CITY OF SACRAMENTO
1231 I Street, Sacramento, CA 95814

Permit No: 0103883
Insp Area: 3

Site Address: 7608 TIERRA GLEN WY SAC
Parcel No: 043-0240-006

Nature of Work: GARAGE CONVERSION TO STUDIO.

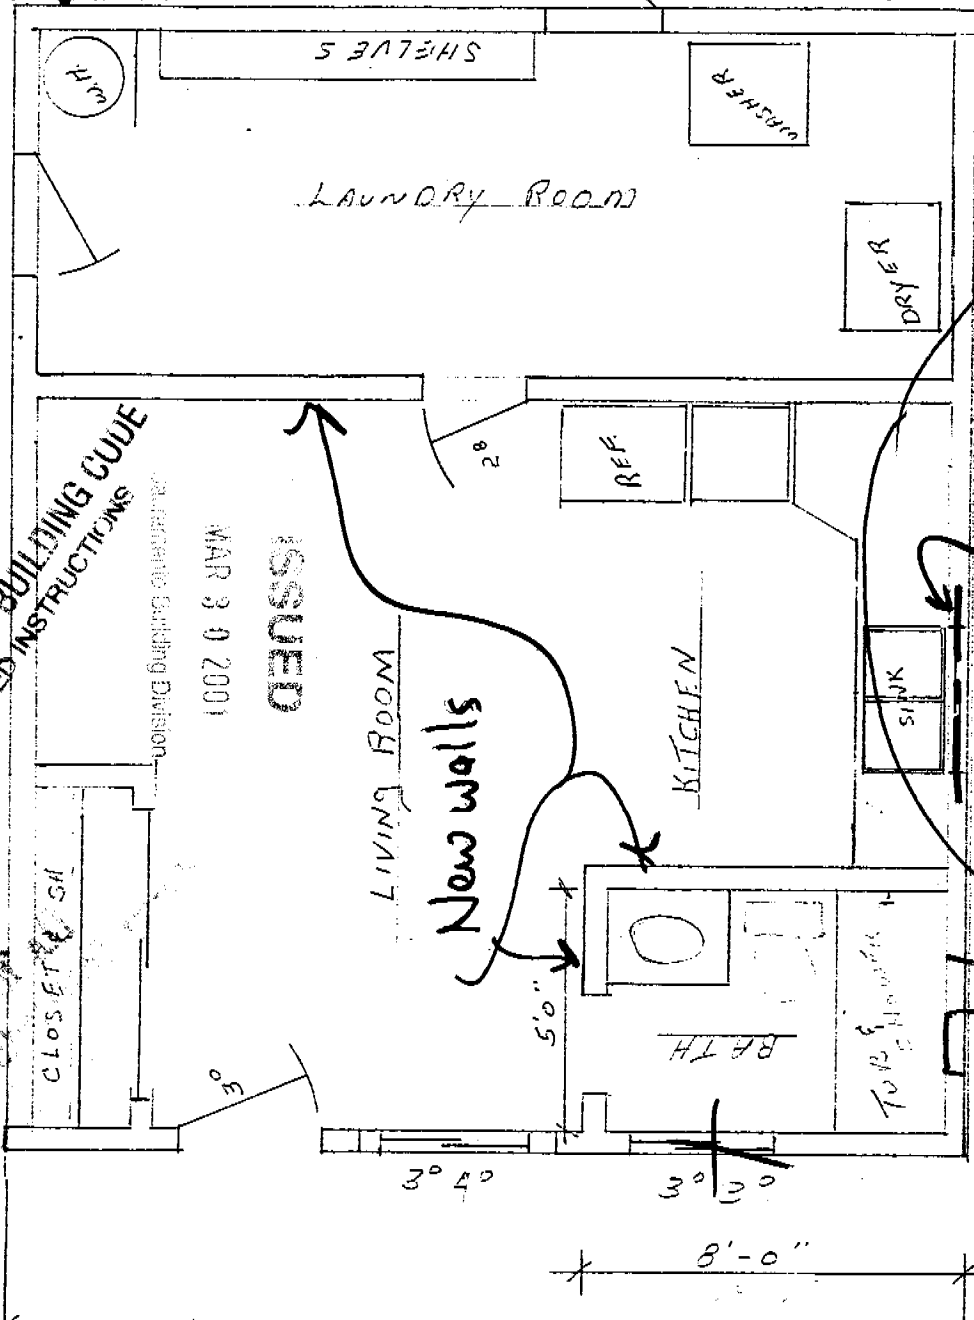
Provide venting for w.H.

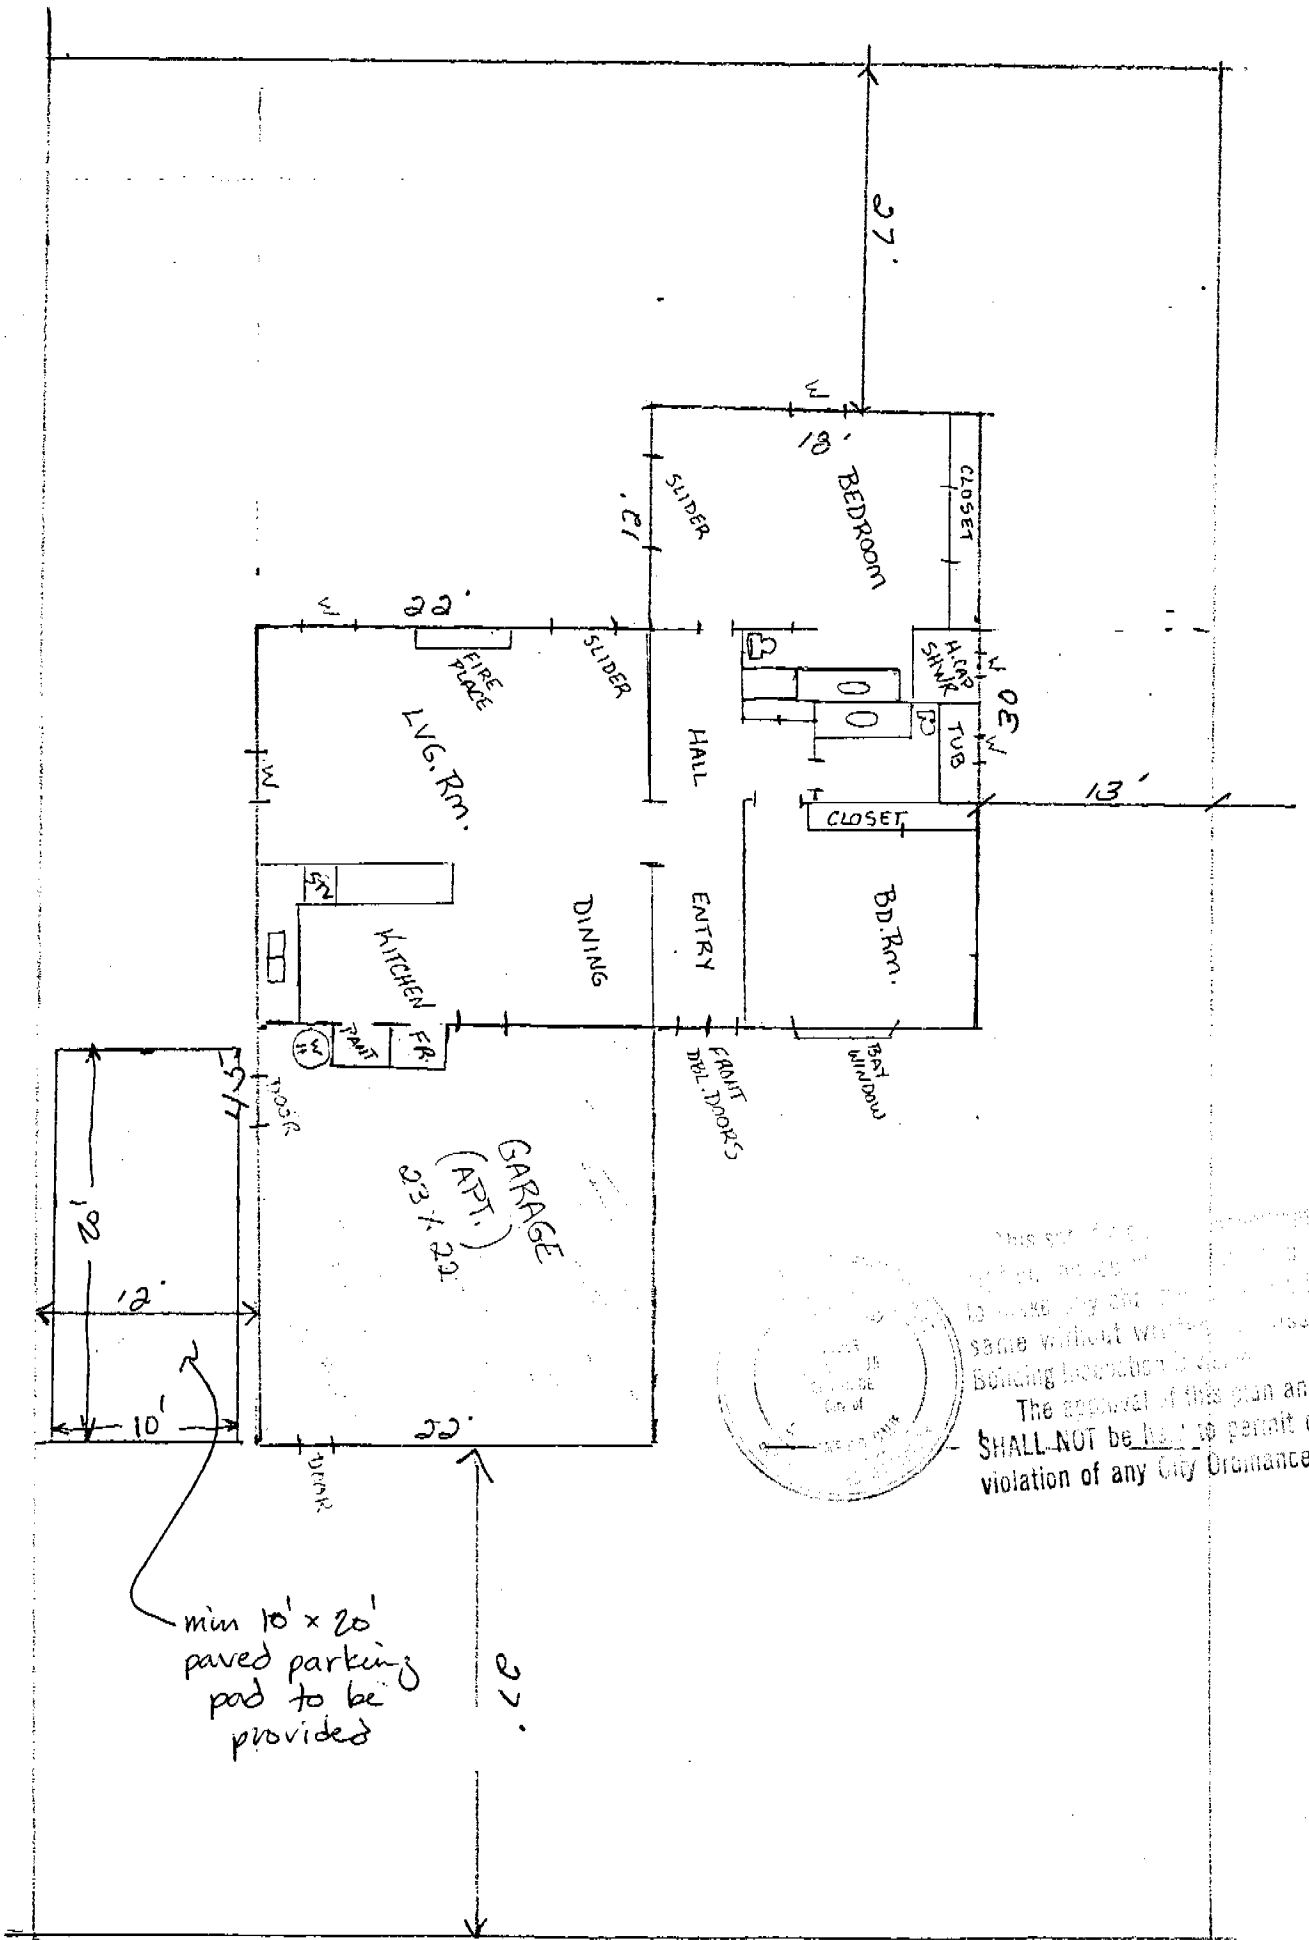
VERIFY 4x6 HDR DF #2 MIN. 4/13/01

- Scope:
- All plumb. fix + cabinets new
 - New walls

RECOMMEND ~~doors~~ to be sealed w/ approved sealer. 460 #1
Reviewed by Matt P. 3/30/01
7608 TIERRA GLEN WAY
